UNITED STATES DEPARTMENT OF COMMERCE
Patent and Trademark Office

Office Action Summary

09/115,764

REASONER

FIG. 4

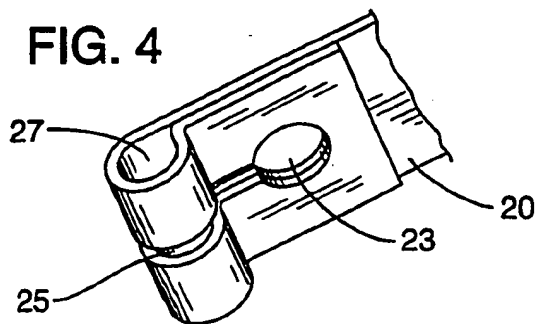
1. The drawings are objected to under 37 CFR 1.83(a). The drawings must show every feature of the invention specified in the claims. Therefore, the claimed features such as: (a) the overall length of the first and second conduit sections, and the shortening of the overall length of the first and second conduit sections in claims 1 and 17-19; and (b) the *shortest* overall length of the conduit in claim 15 must be shown, *or the features canceled from the claims. No new matter should be entered.*

Note that Figs. 1, 3 and 4 merely show portions of the first and second conduit sections 14 and 16, not their overall length. The shortening and the shortest overall lengths of the conduit sections are required to be shown in accordance with 37 C.F.R. 1.84(h), *or the features canceled from the claims.*

NOTE THAT L1 IS SHORTER THAN L2 AS MEASURED BY A RULER
EXHIBIT

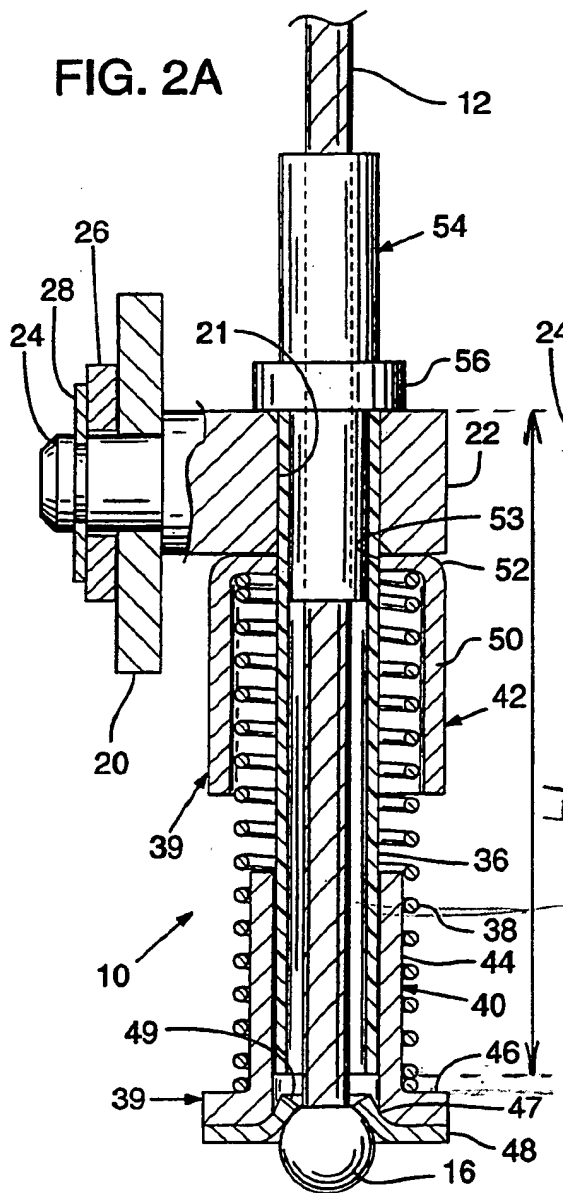
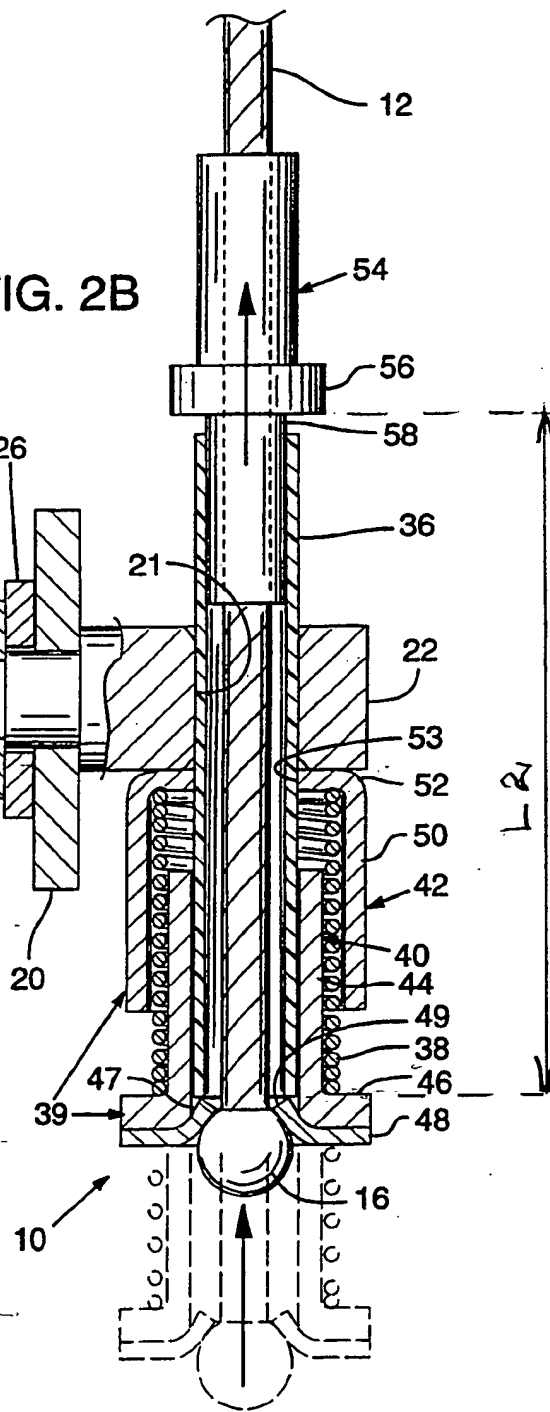
Regarding claim 17, as the spring 38 is compressed axially (Fig. 2B), the first conduit 36 is pulled and the second conduit 58 (i.e., the fitting 54) moves away, consequently, the overall length of the conduit sections 36 and 58 are inherently lengthened. See lines 18-30 of column 7. Further, as the spring 38 is expanded axially (Fig. 2A), the first conduit 36 is retracted backwardly and the second conduit 58 (i.e., the fitting 54) moves forwardly until the fitting 54 is stopped by the pivot coupling 22, consequently, the overall length of the conduit sections 36 and 58 are inherently shortened. See lines 47-53 of column 7 and the Exhibit attached. It is well settled that the functional limitations of a claim may not be given patentable weight where those limitations are inherent in a prior art reference. *In re Schreiber*, 44 U.S.P.Q.2d 1429 (CAFC 1997).

(a) Fig. 2B shows that as the spring 38 is compressed axially, the first conduit 36 is pulled and the second conduit 58 (i.e., the fitting 54) moves away, consequently, the

(b) Fig. 2B shows that as the spring 38 is expanded axially, the first conduit 36 is retracted backwardly and the second conduit 58 (i.e., the fitting 54) moves forwardly until the fitting 54 is stopped by the pivot coupling 22, consequently, the overall length of the conduit sections 36 and 58 are shortened. See lines 47-53 of column 7.

For applicant's convenience, the examiner attached the Exhibit wherein L1 is the overall length of the first and second conduit sections 36 and 58 when the spring is expanded (Fig. 2A), and L2 is the overall length of the first and second conduit sections 36 and 58 when the spring is compressed (Fig. 2B). Applicant is respectfully advised to use a ruler and measure the lengths of L1 and L2. Applicant would recognize that L1 is shorter than L2. It has long been settled law that a claimed invention may be anticipated or rendered obvious by a drawing in a reference, whether the drawing disclosure is accidental or intentional. *In re Meng*, 181 U.S.P.Q. 94, 97 (CCPA 1974) and *In re Mraz*, 173 U.S.P.Q. 25 (CCPA 1972). On the other hand, the functional limitations of a claim may not be given patentable weight where those limitations are inherent in a prior art reference. *In re Schreiber, supra*.
